STAFF RECOMMENDATION 1706 Sweetbriar Avenue August 21, 2013

Application: New construction--addition; Demolition--outbuilding
District: Belmont-Hillsboro Neighborhood Conservation Zoning Overlay
Council District: 18
Map and Parcel Number: 11704001100
Applicant: Van Pond, Architect
Project Lead: Melissa Baldock, melissa.baldock@nashville.gov

<p>Description of Project: The application is to construct a new one-story addition to a one-and-a-half story house. The application also involves demolishing a non-contributing outbuilding.</p>	<p>Attachments A: Photographs B: Site Plan D: Elevations</p>
<p>Recommendation Summary: Staff recommends approval of the project with the conditions that staff approve a brick sample and all window and door specifications, and that the utility connections be located at the rear or on a side façade beyond the midpoint of the house.</p>	
<p>With these conditions, staff finds that the new addition and the demolition of the outbuilding meet Sections II.B. and III.B.2. of the <i>Belmont-Hillsboro Neighborhood Conservation District Handbook and Design Guidelines</i>.</p>

Figure 2. The shed that is to be demolished.

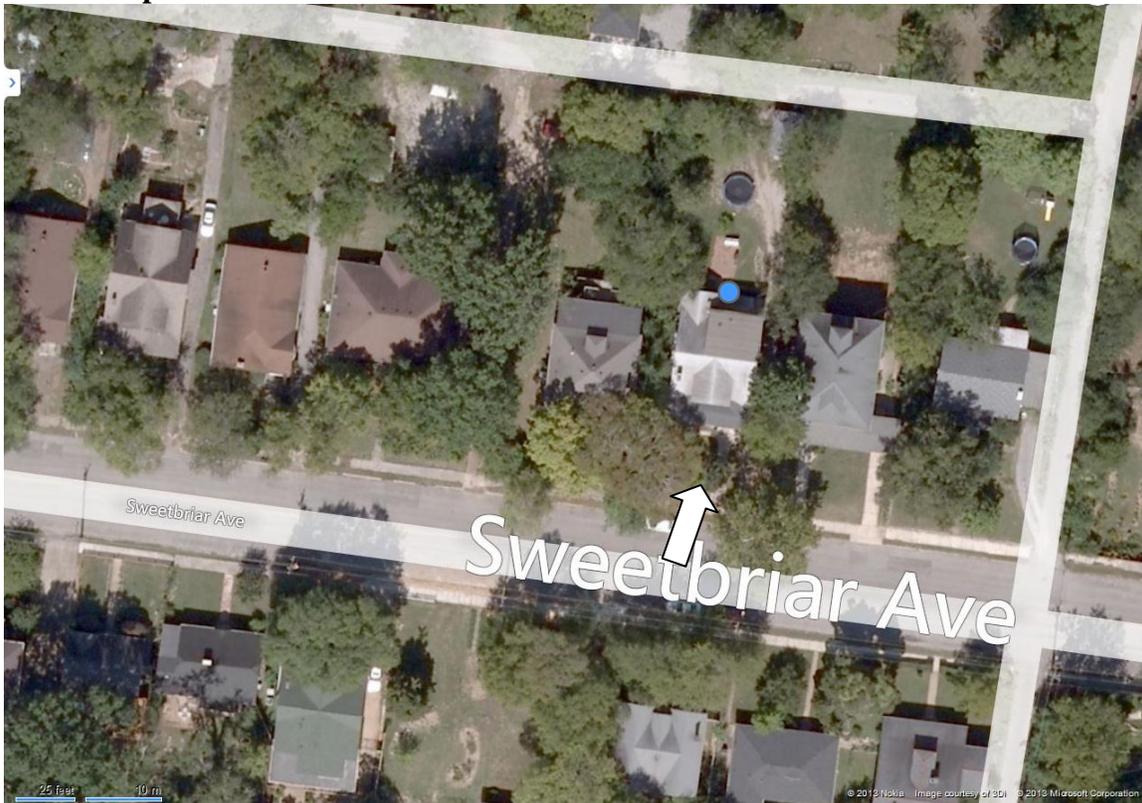
Demolition: The application involves demolishing a rear yard shed that is approximately two hundred and fifty square feet (250 sq. ft.) (Figure 2). The date of construction of the shed is unknown, but staff finds that it lacks historic or architectural integrity and that it does not contribute to the historic character of the site or district. Staff therefore finds

that the demolition of the shed meets Section III.B.2. of the *Belmont-Hillsboro Neighborhood Conservation Zoning Overlay: Handbook & Design Guidelines*.

Proposed Main Floor Plan

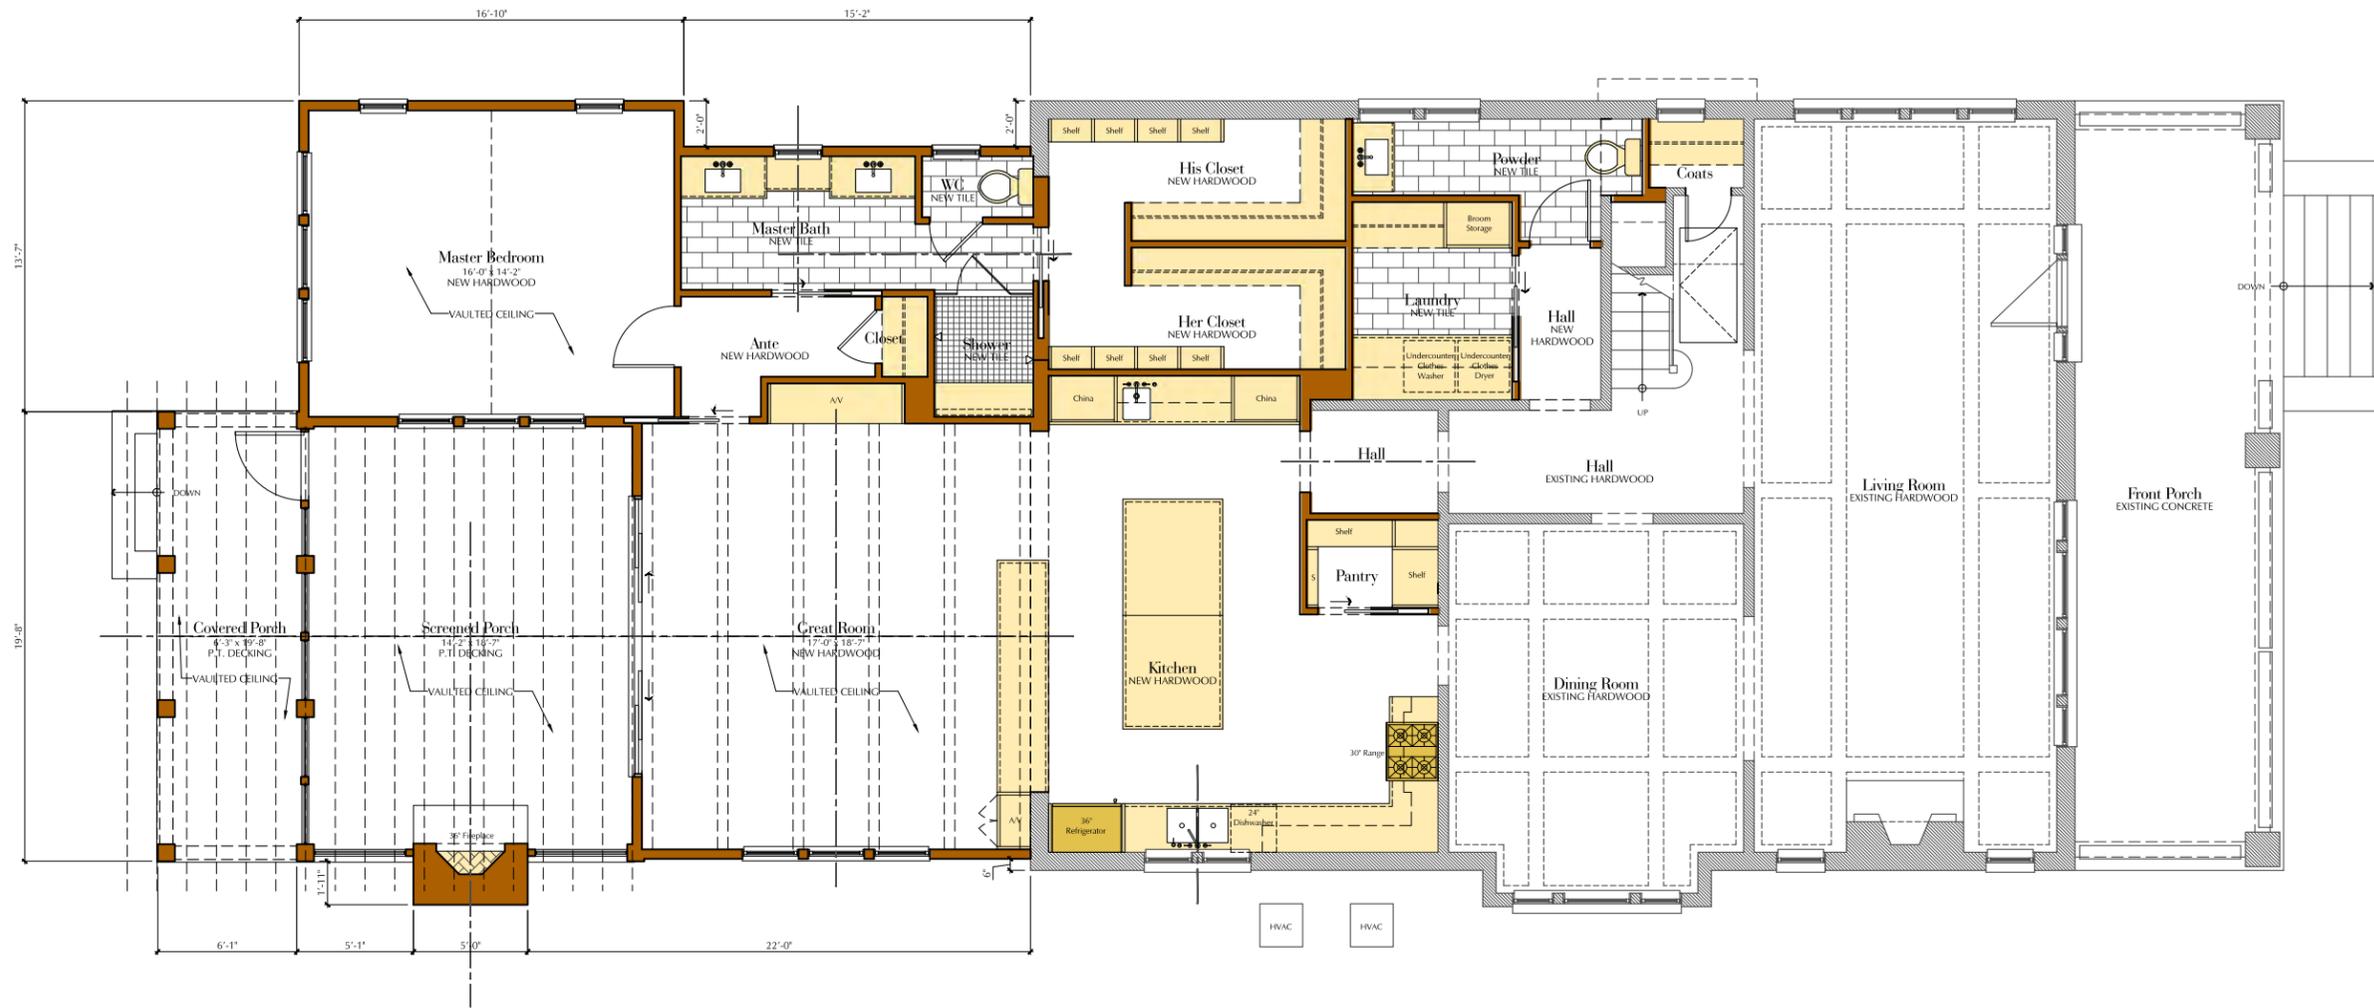
Location, Height and Scale: The addition is located fully to the rear of the historic house and is not wider or taller than the existing house. On the right side, the addition steps in two feet (2') from the back wall of the house. After a depth of fifteen feet, two inches (15'2"), the addition steps back out to match the line of the house. On the right side, the addition only steps in six inches (6") from the back side wall of the house. Typically, staff asks that one-story additions step in a minimum of twelve inches (12"). In this case, staff finds that the six inch (6") inset is appropriate for several reasons. The house is stone, and the addition will be clad in siding, so there will be a change in material to differentiate the historic house from the addition. Also, because the addition will be more than seven feet (7') shorter than the historic house, the addition will be visually distinct from the historic house and a shallow inset is acceptable.

The addition will have a maximum width of thirty-five feet, four inches (35'4") and a maximum depth of thirty-eight feet, three inches (38'3"), which includes a screen porch at the rear. By comparison, the historic house is also thirty-five feet, four inches (35'4") wide, and is approximately fifty-four feet (54') deep. The historic house has a maximum ridge height of twenty-five feet (25'). The addition will be lower in height, with a ridge height of approximately seventeen feet (17'). The eave height of the addition will match that of the historic house.

Staff finds that the addition's location, height and scale are appropriate and meet sections II.B.a and b. and II.B.2. of the *Belmont-Hillsboro Neighborhood Conservation Zoning Overlay: Handbook & Design Guidelines*.
